Proposed Car Park Extension

Bersham Hall, Bersham Road, Wrexham

Our reference: LB/230585/TN01 – Rev06

Date: 09 August 2024

Drawing No.	SCP/230585/SK02
Rev.	-

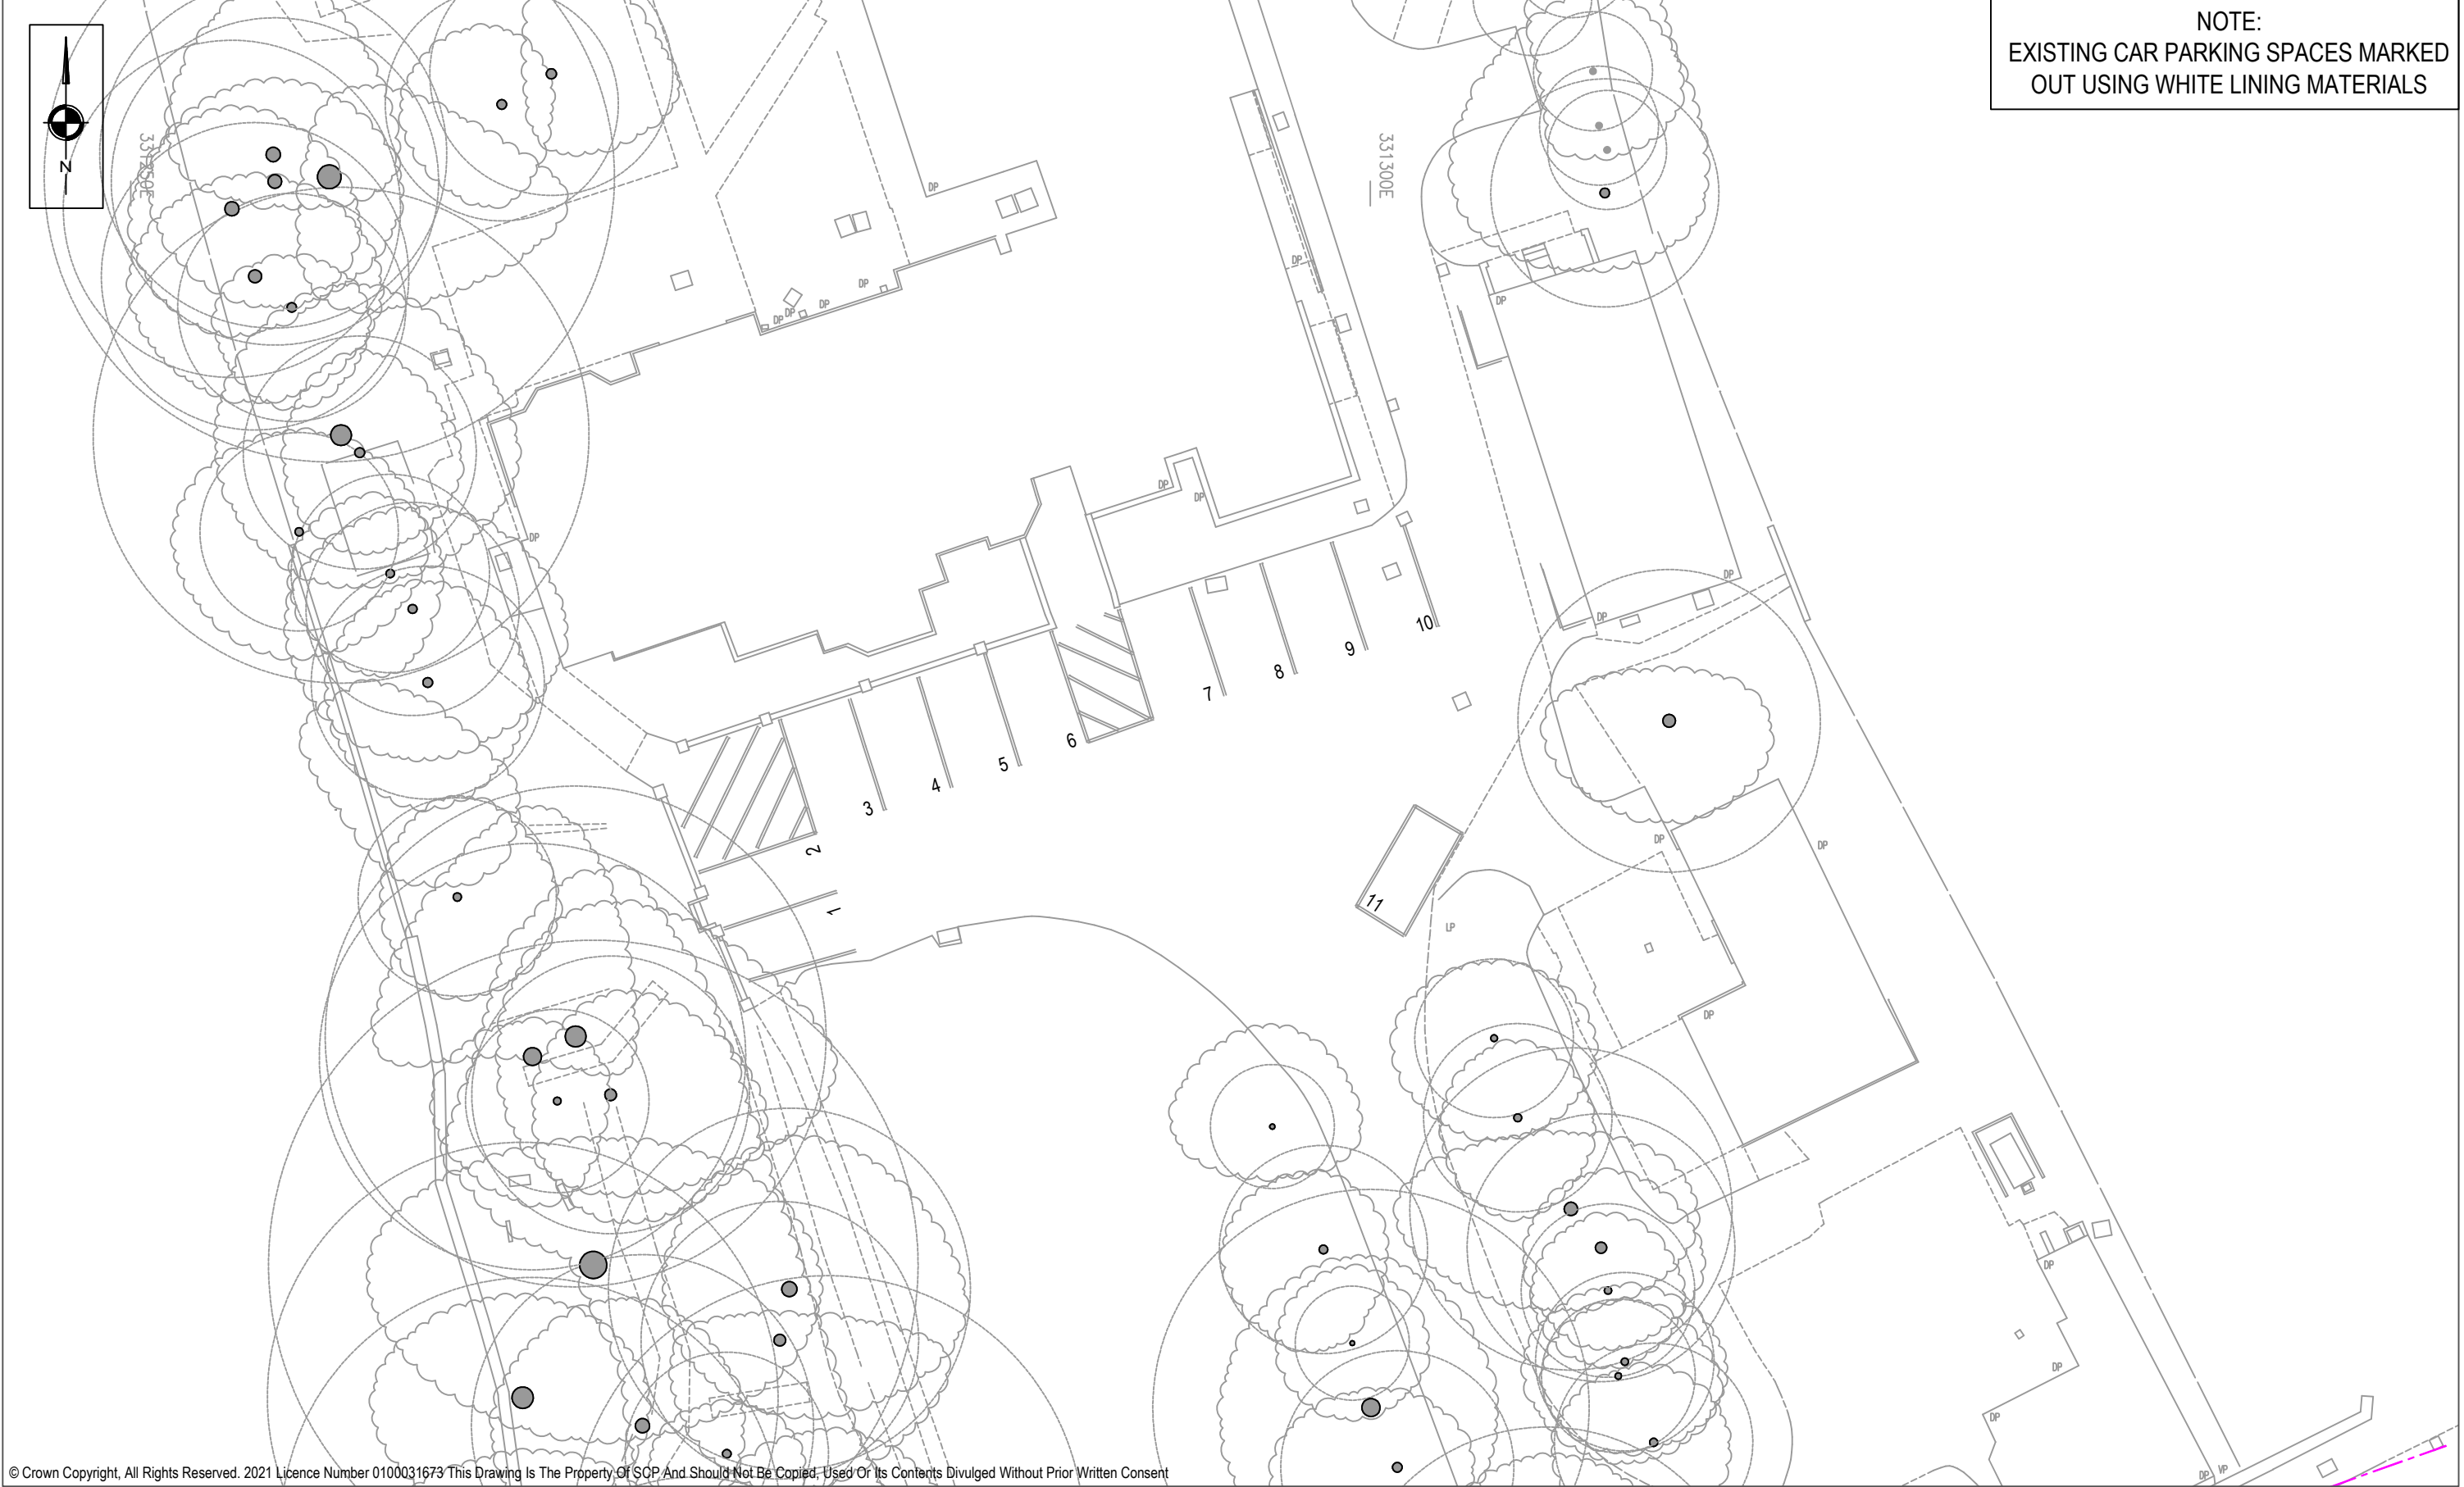
The existing car park at the school has around 11 spaces. I understand that due to the limited parking provision at the site for staff, parents, carers, that an agreement is in place with the adjoining bowling club to utilise their existing car park. However, a planning application (ref: P/2023/0662) is currently being considered for the redevelopment of the Bersham Sports & Social Club to provide 9 no. dwellings. As part of these proposals, the existing parking area associated with the club (part used by the school) will be removed. This loss of parking at the club is intended to be offset by providing the proposed car park at the school and to minimize the potential for on street parking. I also understand that the school will in future be looking to increase the number of children at the school from 50 to 80 which will require 5 additional staff members and increase parking demand at the school.

9. The site currently has formal parking for 11no. spaces at the front of the building, as shown on drawing SCP/230585/SK02 provided in **Appendix B**.

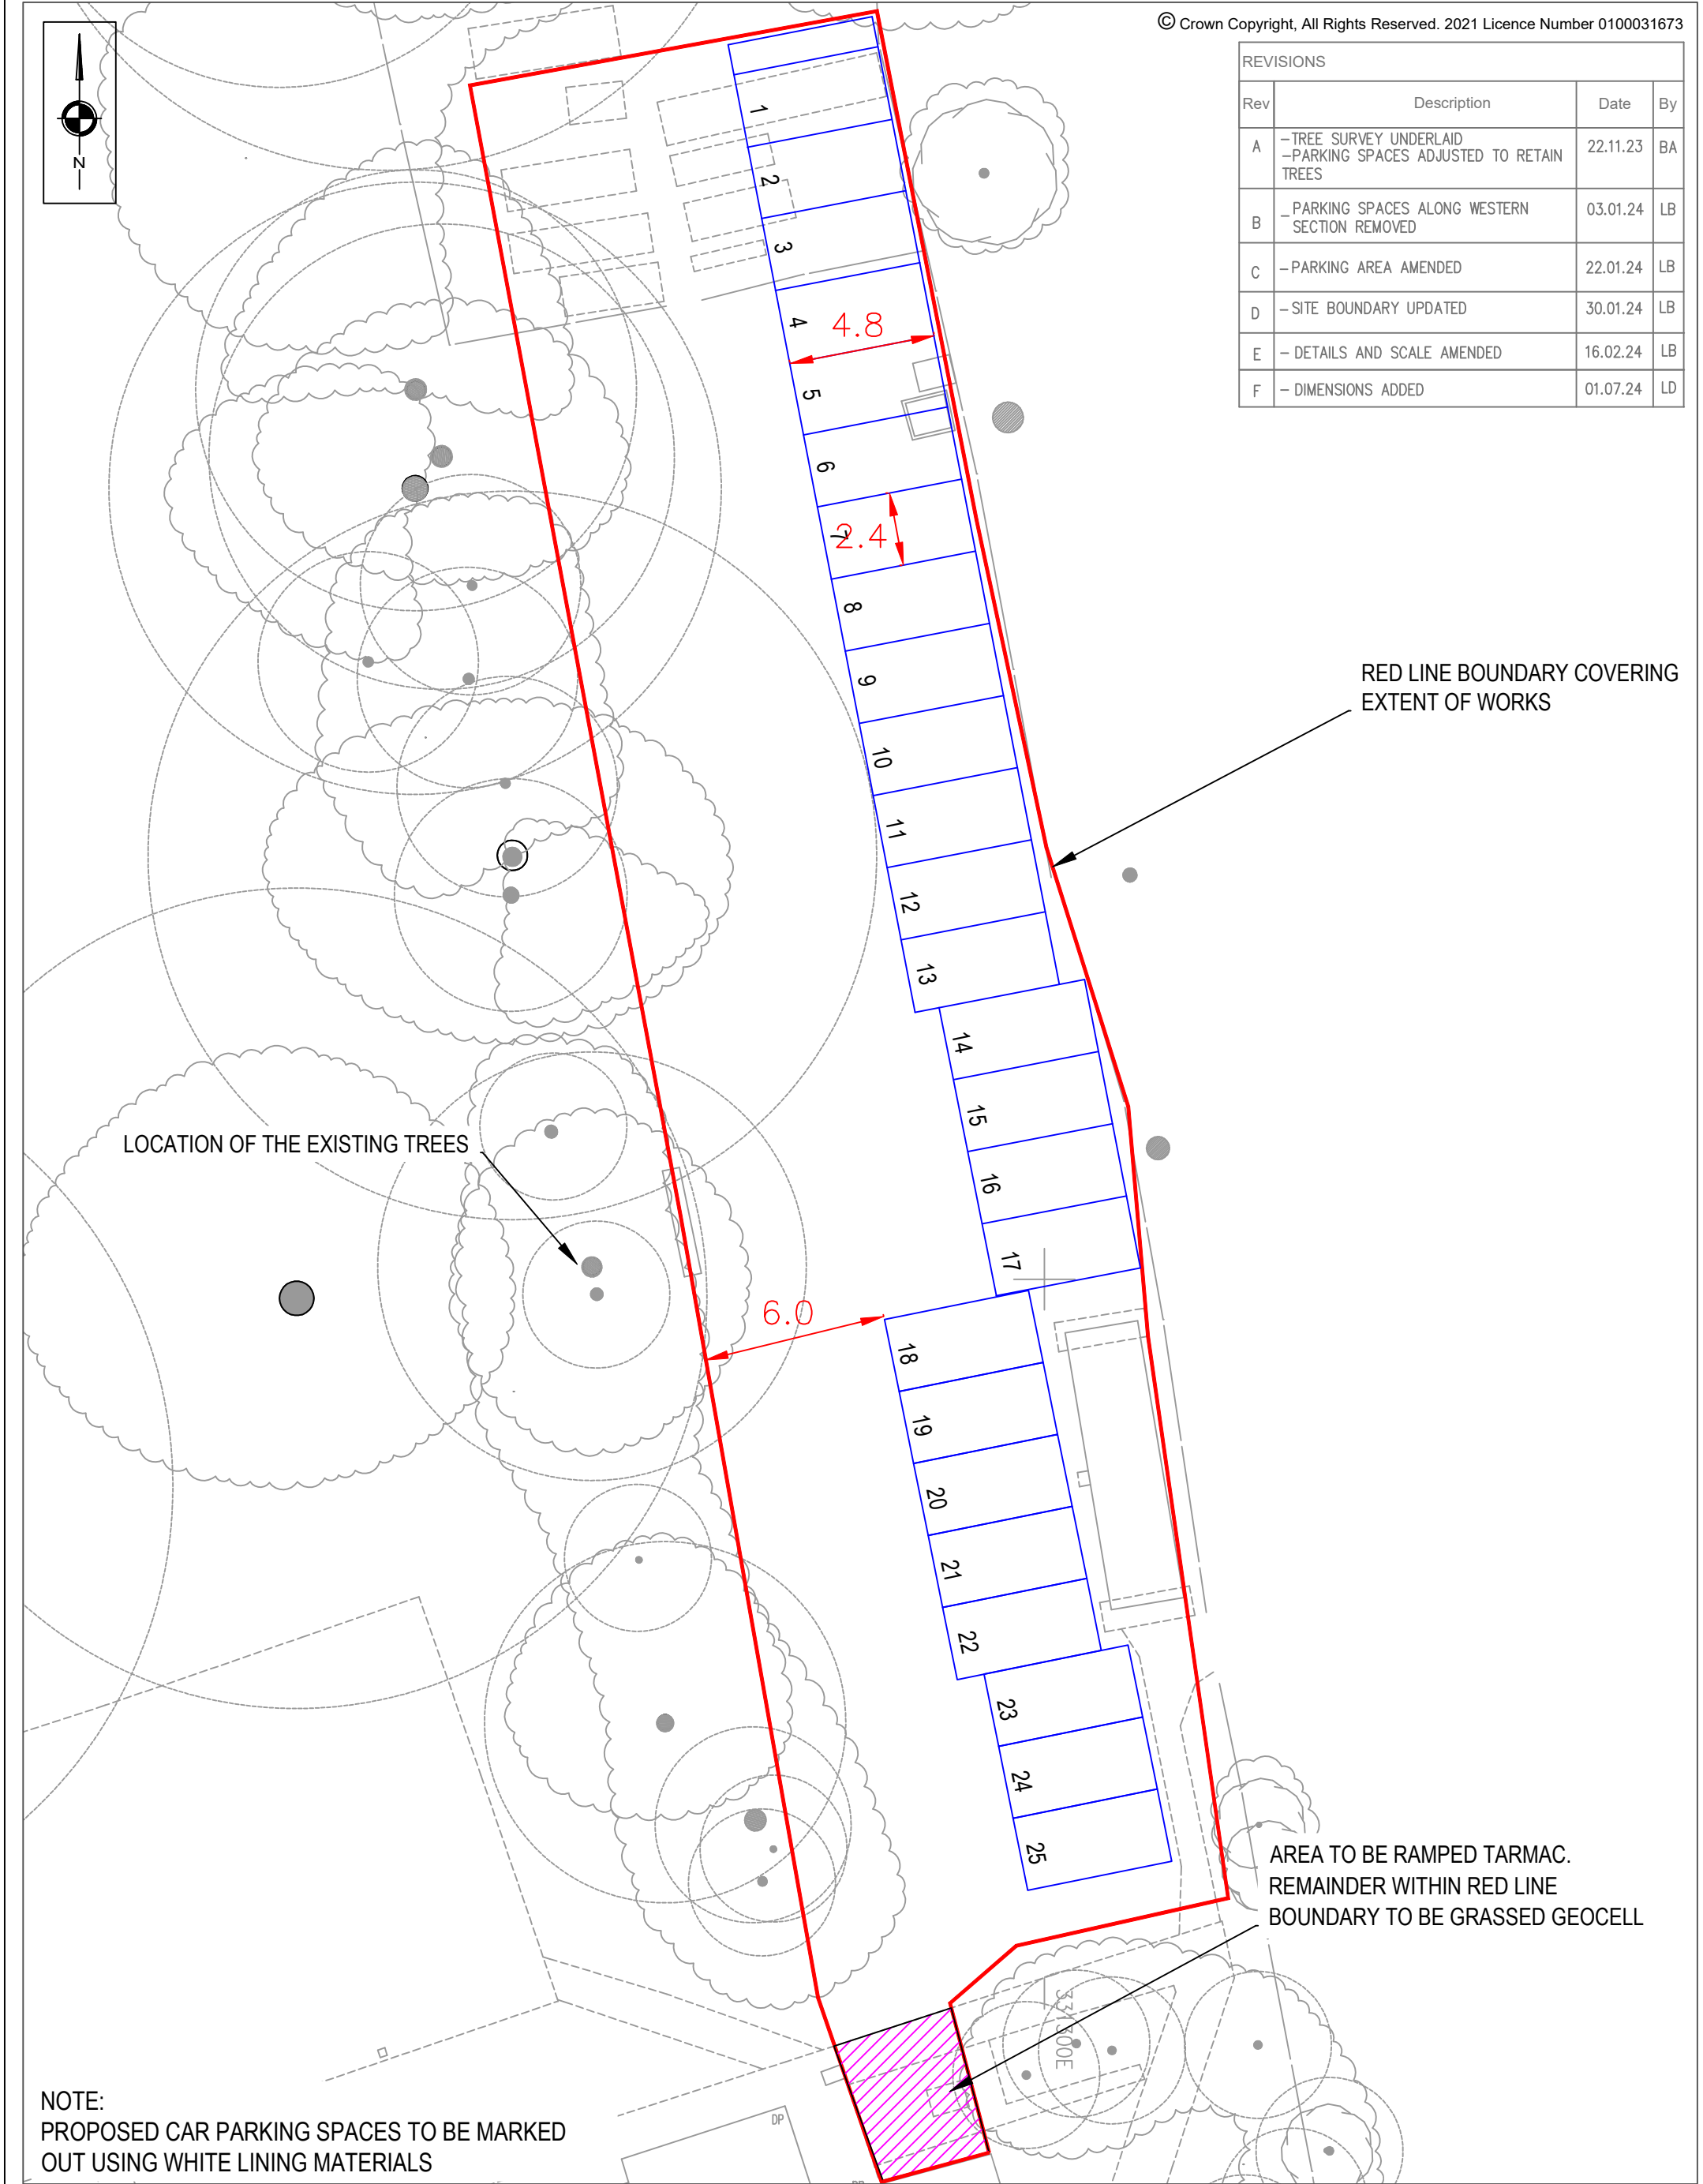
The site currently has parking for around 11 cars fronting the main building. Proposed spaces nos. 18 – 22 do not appear to have 6m clearance behind for turning. **I would recommend that this detail is annotated on a revised layout plan.**

I would recommend that any existing / proposed parking spaces are suitably marked out using white lining materials. I would recommend that this detail is annotated on a revised layout plan.
